CITY OF MADISON
CITY ENGINEERING DIVISION
DEPARTMENT OF PUBLIC WORKS
PLAN OF PROPOSED IMPROVEMENT

PFLAUM ROAD ASSESSMENT
DISTRICT - 2025

CITY PROJECT NO. 14781
CONTRACT NO. 8747

1. REV#1 - ISSUED 8/3/26
2. REV#2 - SHEETS U6-U8, U11-U13, U17, U18, W6, W8, W14, W16, W17, & W24 UPDATED.

MARK	REVISION	DATE	BY
14781		Scale: 1" = 40'	U-2

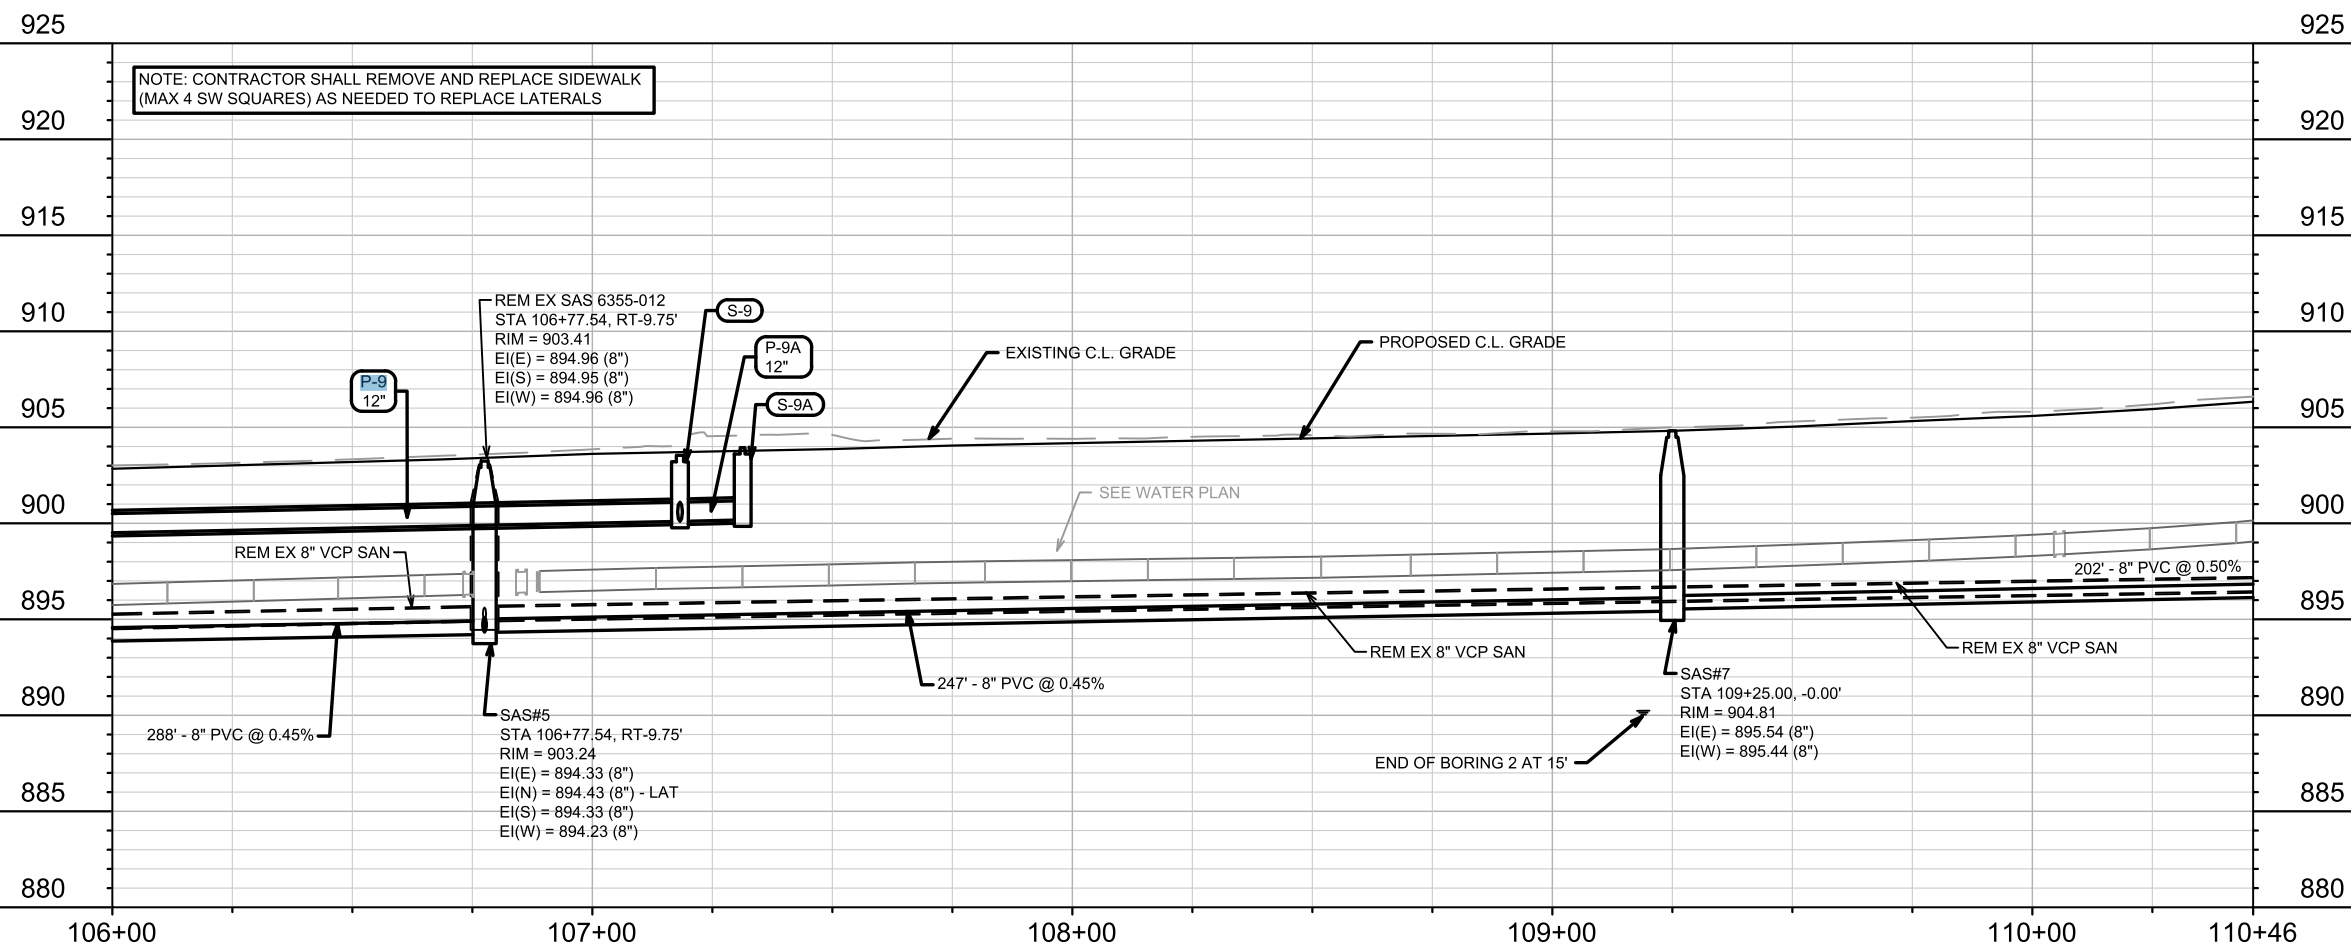
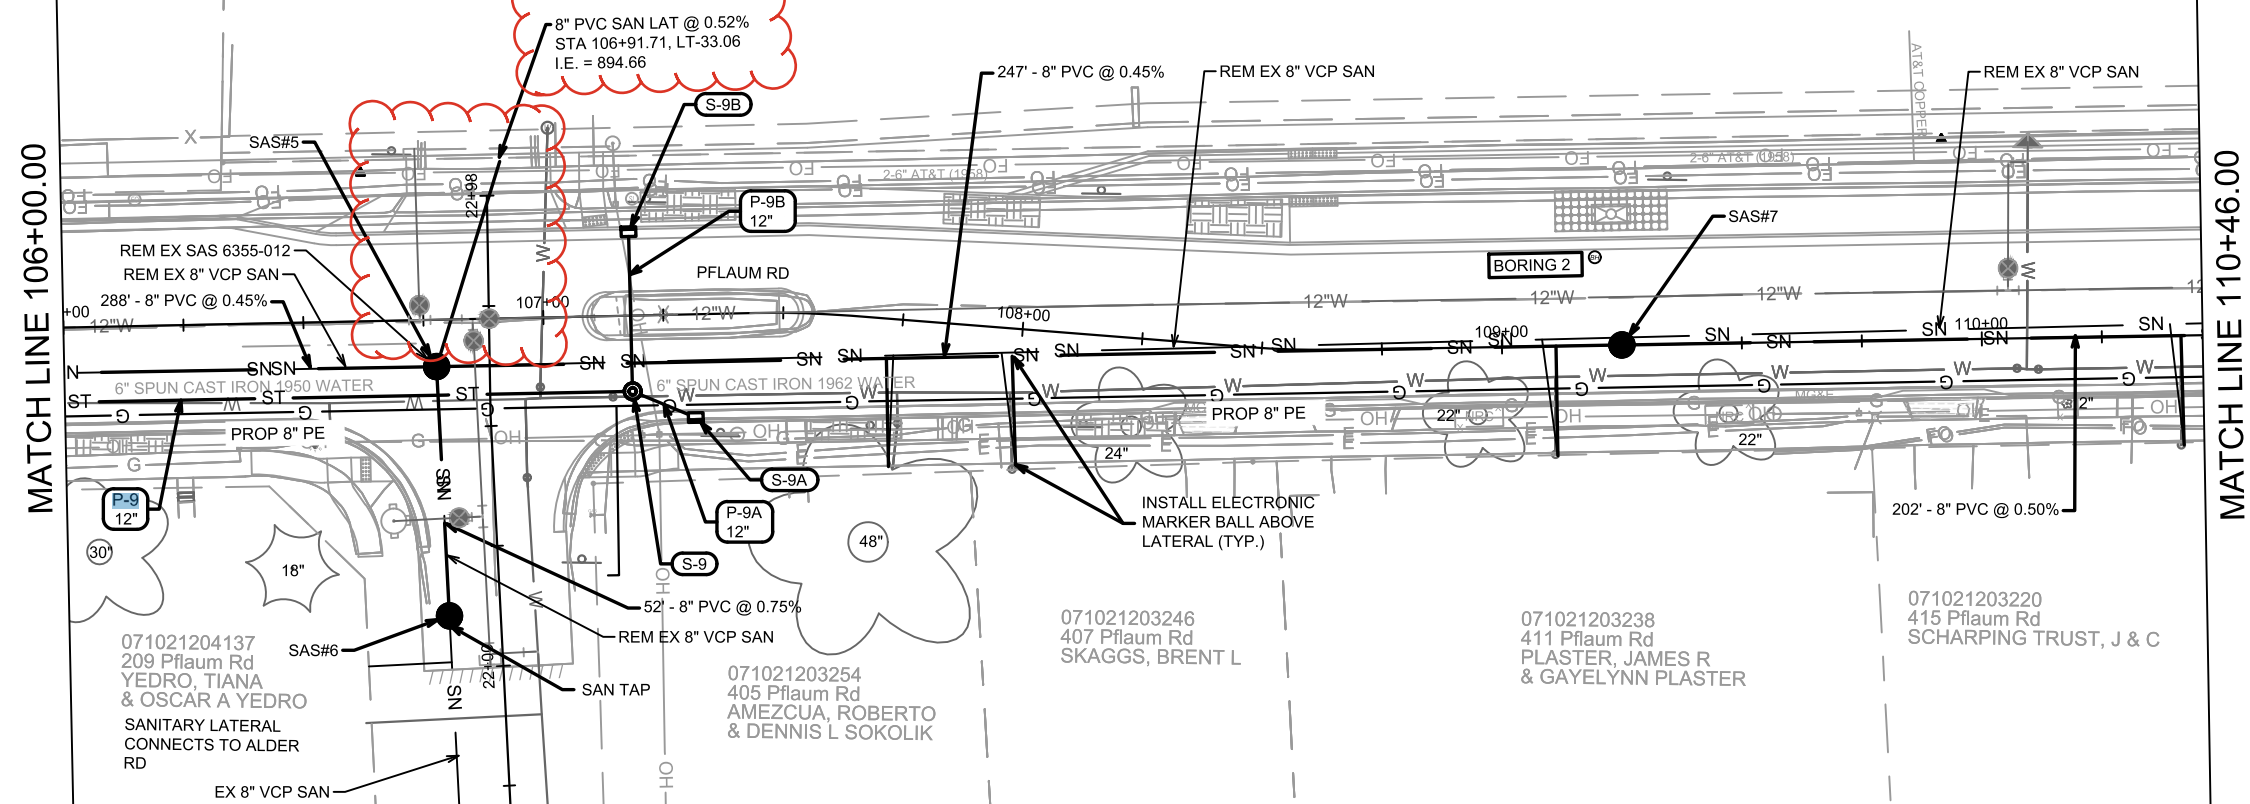
Shifted sanitary lateral connection at property line for the lateral from SAS#5 to 702 Pflaum. Added station, offset, and invert elevation for 8" lateral.

14781		
U-7

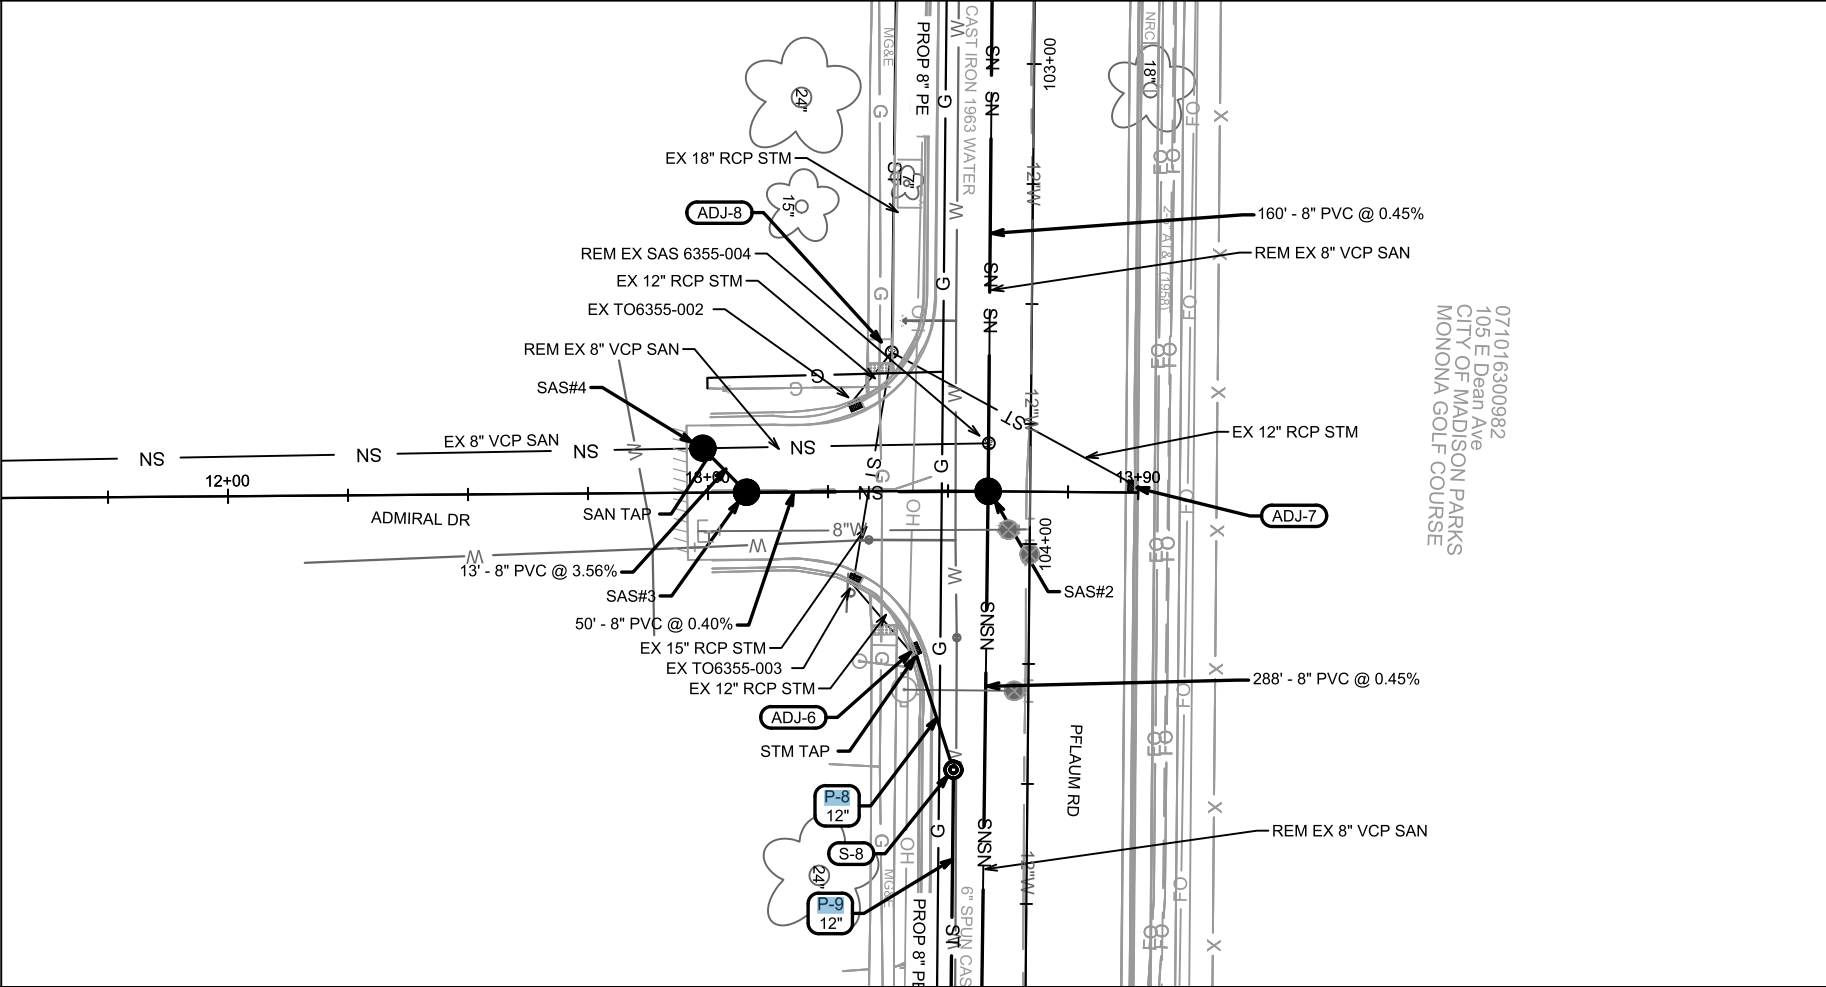
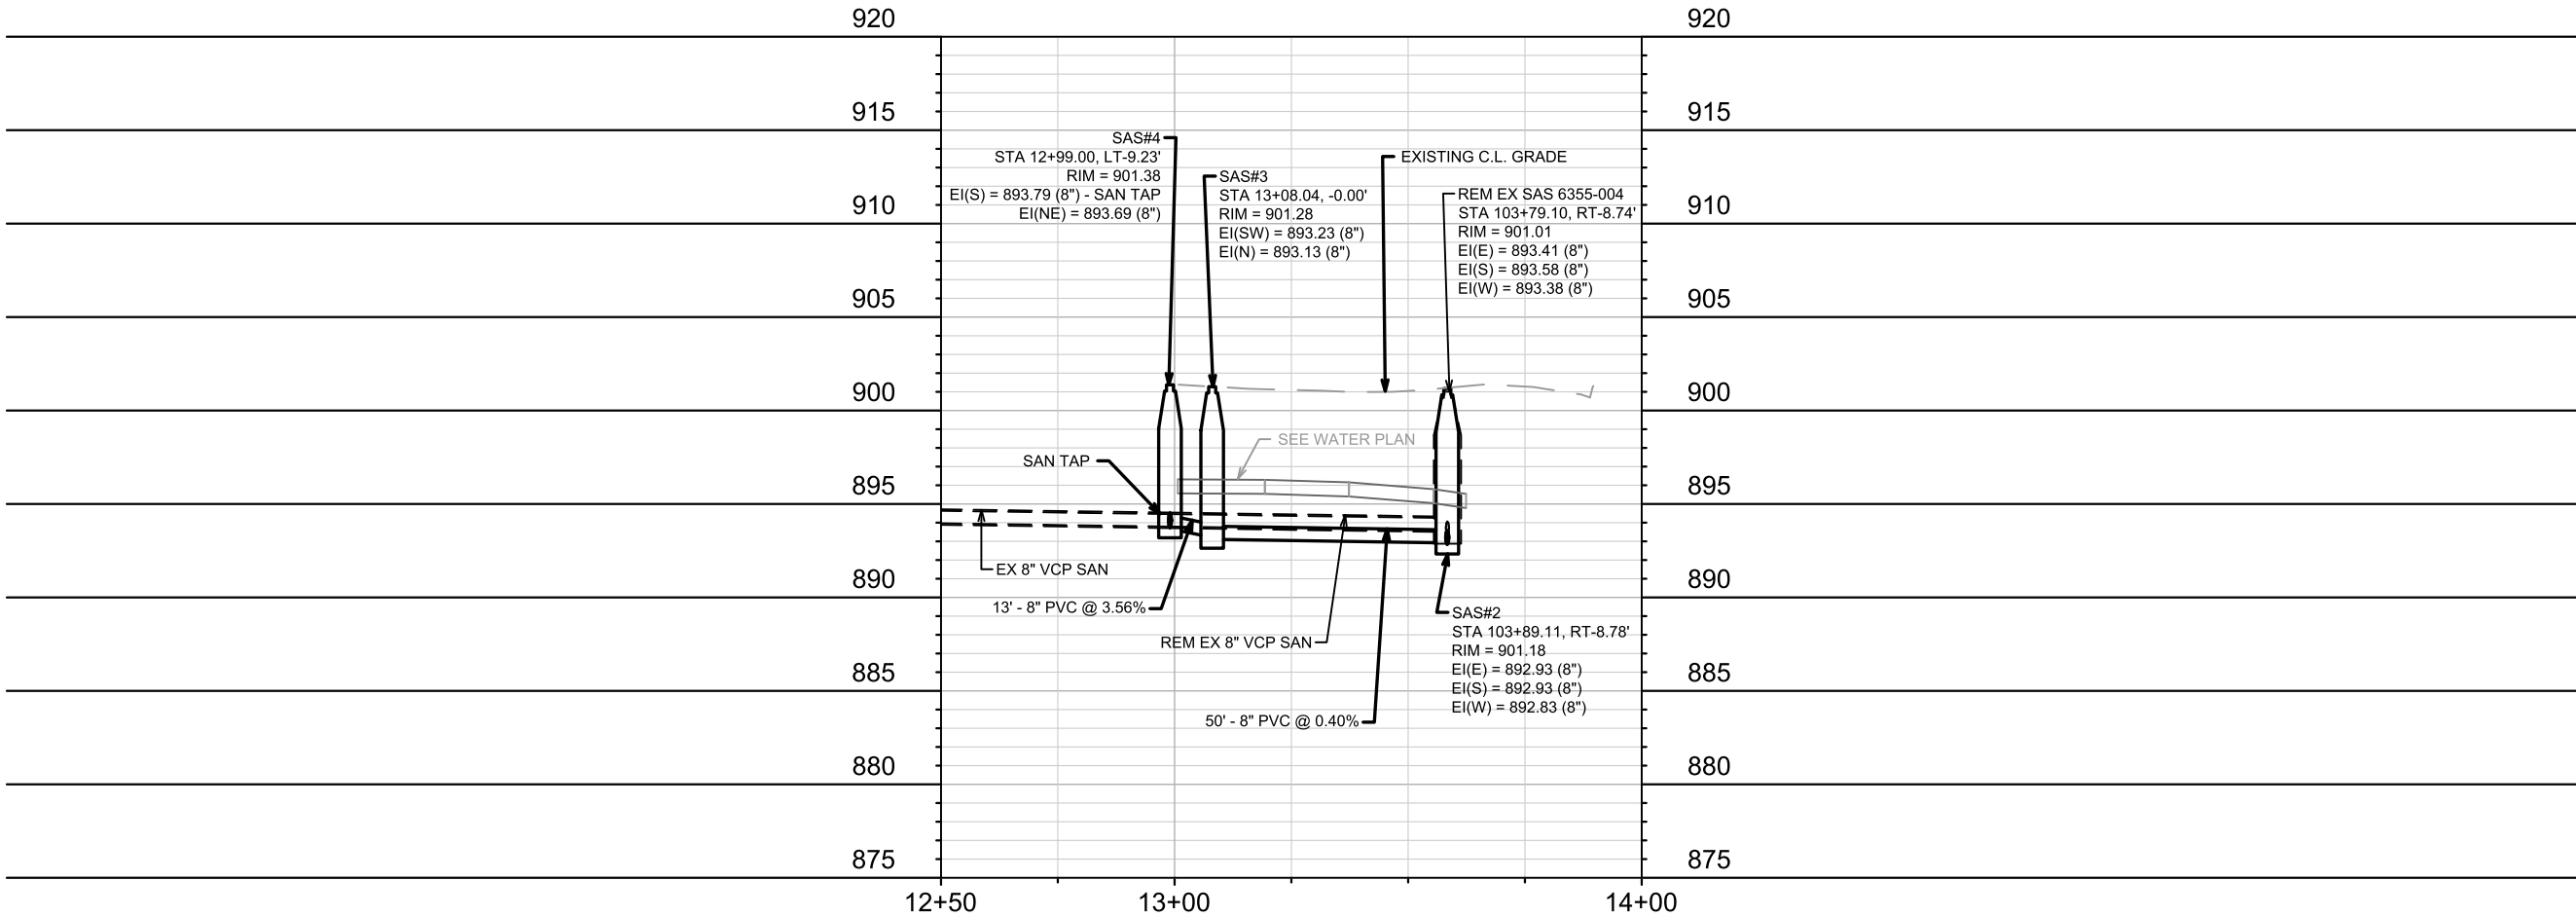
REVISION 2: EKG 8/11/26
Updated ULO locations based on
ULO results. Added ULO8B and
ULO9B.

U-10

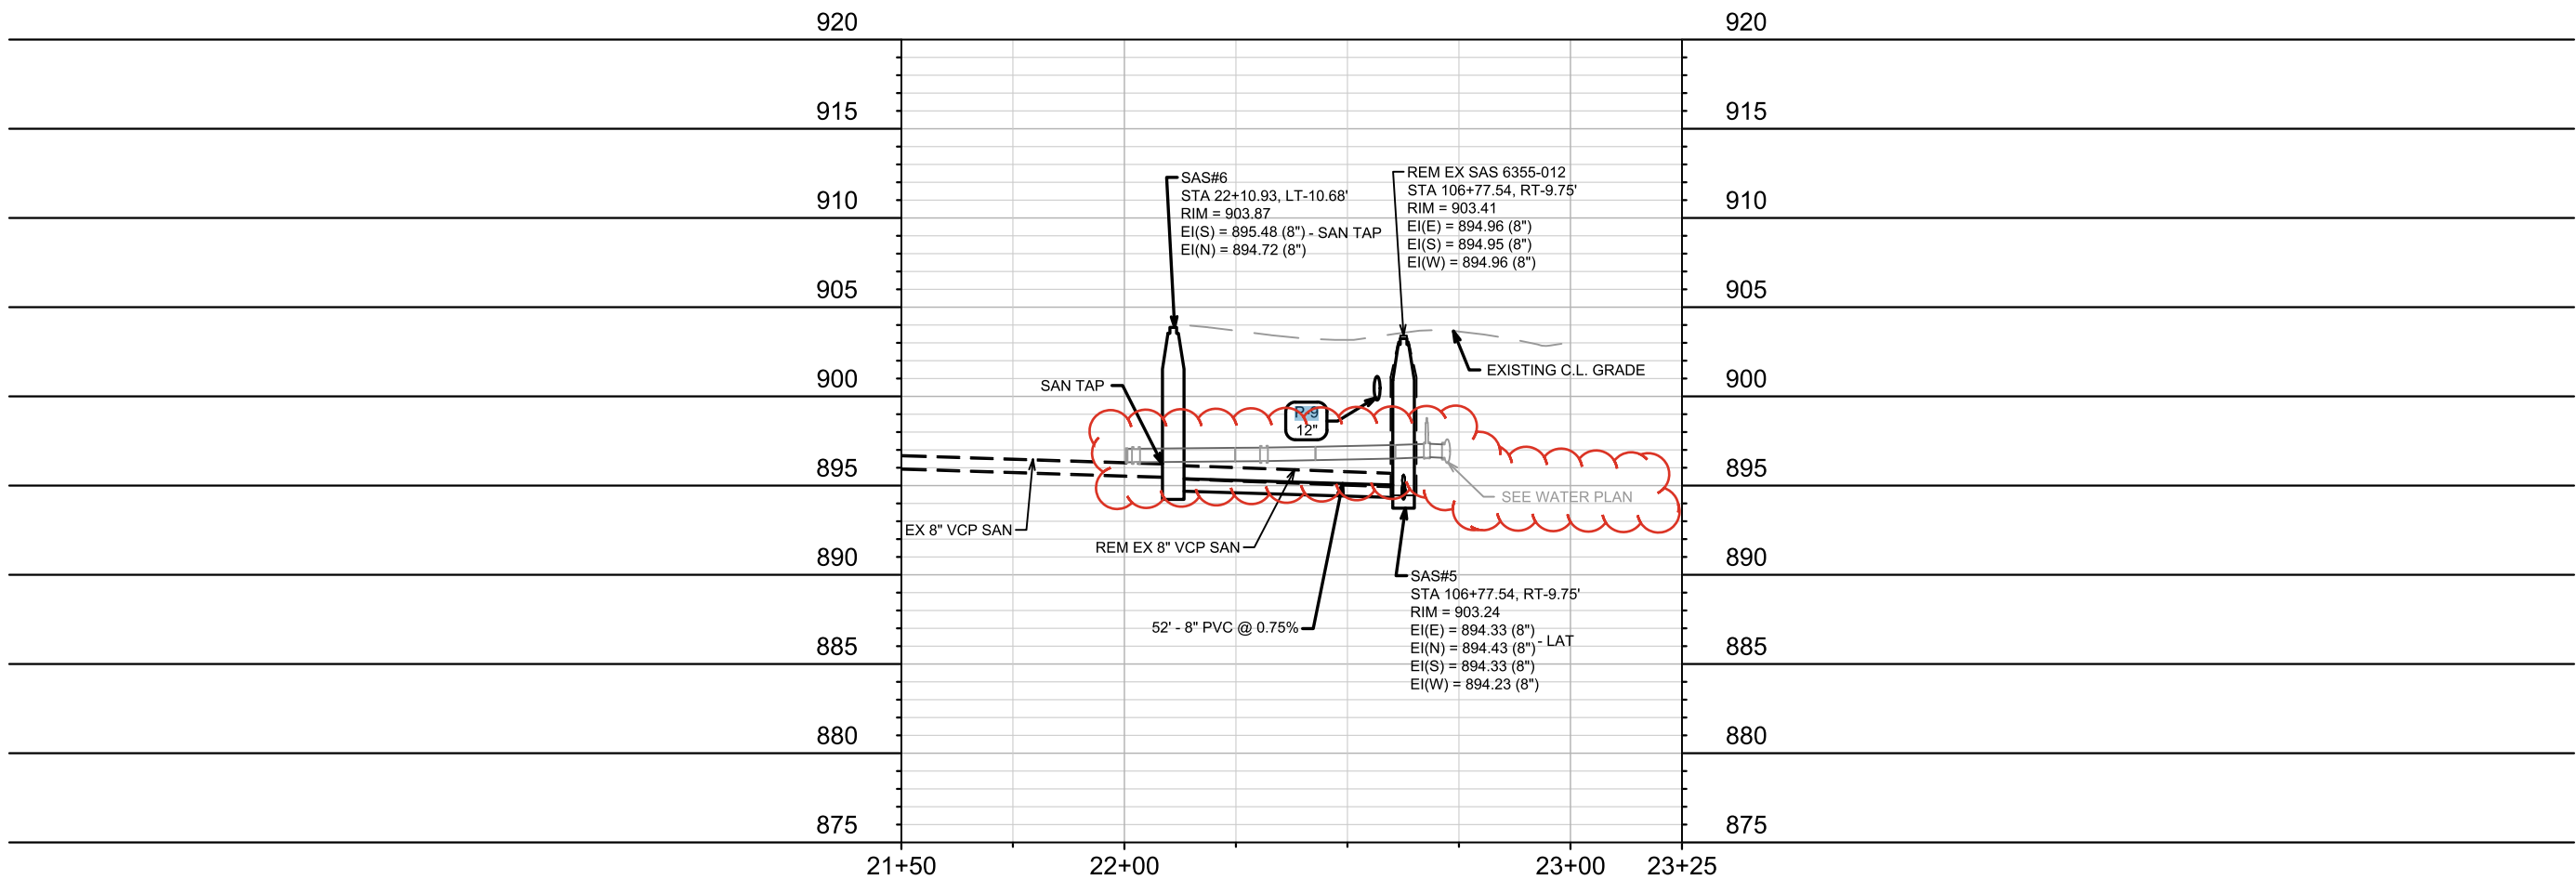
REVISION 1: EKG 7/22/26
Added water plan to profile view.
